# **Report and Recommendations of the University Community Planning Group on the Draft-University Community Plan**

## **University Community Planning Group**

**May 15, 2024**

**Figure 29: University Community Open Space, D-UCP, p 143**

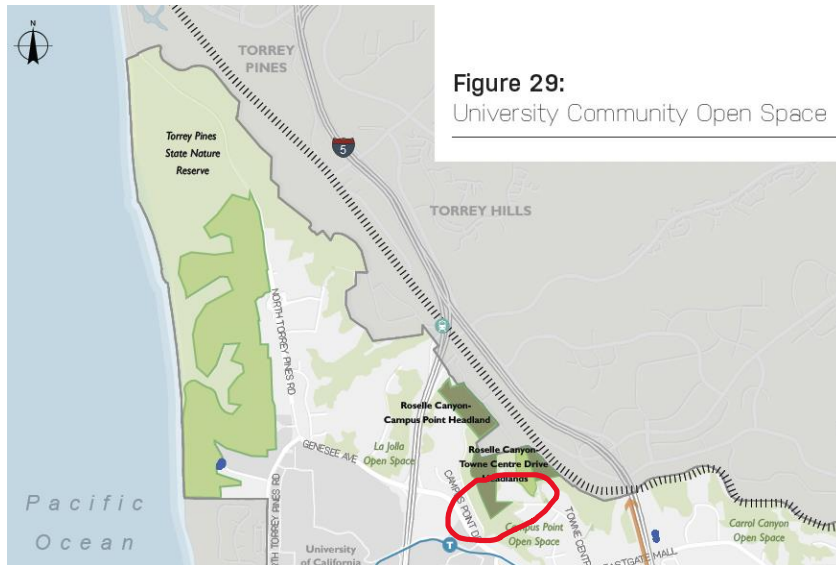
**Figure 29 accurately represents the parcels proposed for dedication** under Charter sect 55. The parcel misrepresented in the D-EIR and Biological Resources Report (K302 P3) is circled in red. K302 P3 includes two sub-parcels (APN: 343-121-01 & 343-121-05)

Figure 4. Post-Project MHPA and Conserved Lands, Biological Resources Report, D-UCP.

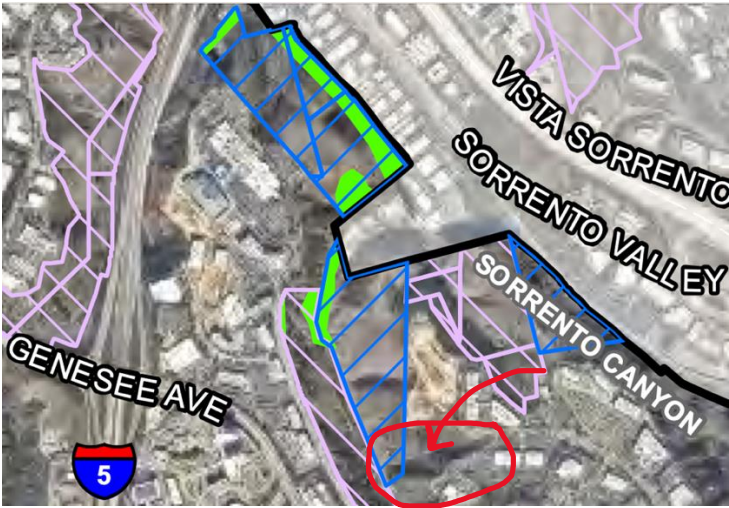
Figure 4 omits a portion of one parcel (K302 P3) proposed for dedication. The missing sub-parcel is APN: 343-121-05. It is approximately 5-acres in size.

- **Please correct errors** to ensure consistency between the Draft UC Plan and the environmental documents that support it.
- **Please revise the D-EIR, the Biological Resources Report (Fig 4-5), and the Proposed Zoning Map** to ensure that city owned open space parcels to be dedicated pursuant to Charter section 55 are described accurately and consistently in every part of the Final University Community Plan.
- **Please revise the D-EIR, the Biological Resources Report (Fig 4-5), and the Proposed Zoning Map** to ensure that all of parcel K302 P3 (sub-parcels APN: 343-121-01 & 343-121-05) are included in the Final UCP and associated documents.

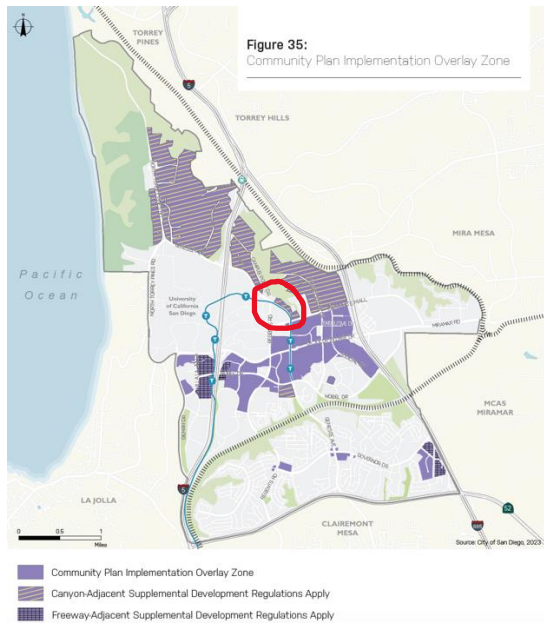
\* **Based on SDR C.2, the redrawn CPIOZ for “Canyon-Adjacent Supplemental Development Regulations,” described in Figure 35 is not accurate.**<sup>18</sup>

Based on the definition selected in SDR C.2, Figure 35 is no longer accurate. “Canyon Adjacent Supplemental Development Regulations” do not apply to the region mapped.

- Please clarify that SDR C.2 applies to “Development” in general (in conformity with CPIOZ area in Fig 35, p 186.
  - Please restore explanatory section introducing SDR C.2.  
“Canyon-Adjacent Development The purpose and intent of these supplemental development regulations are to provide design regulations to lessen the effect of buildings developed adjacent to open space areas designated in this community plan.”  
(See Discussion Draft, SDR 21, p 201)

**Please complete UCPG recommendation to fully correct Fig 29:**

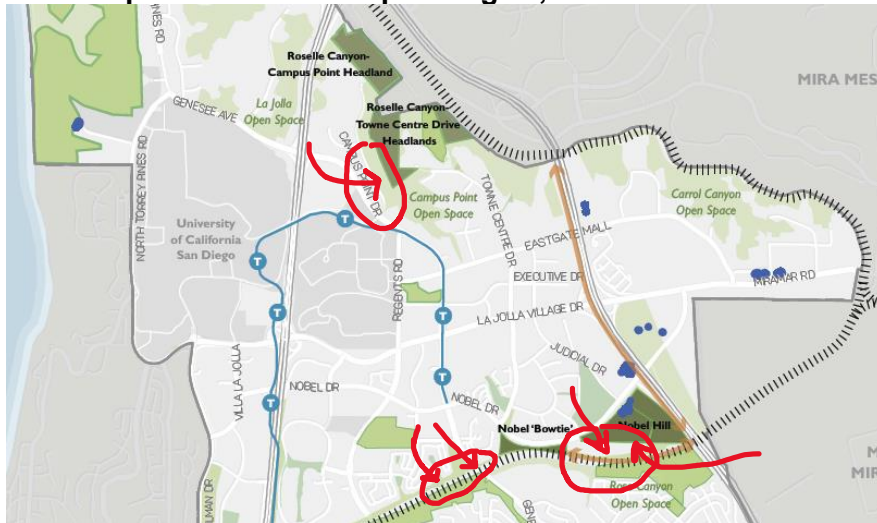
- Update Fig 29 to include ALL dedicated open space in UC.
- Currently, three noticeable parcels are missing.
- Please update map to include the following dedicated open space parcels:
  - Campus Point Open Space (west slopes of Roselle Canyon)
  - Lucera finger canyons (east Rose Canyon)
  - Monarch property (east Rose Canyon/Nobel Hill)
- The same error applies to Figures 2, 3, 4, 5, 6, 13, 18, 20, 22, 23, 24, 26
- Update base maps throughout D-UCP to accurately reflect existing dedicated open space.
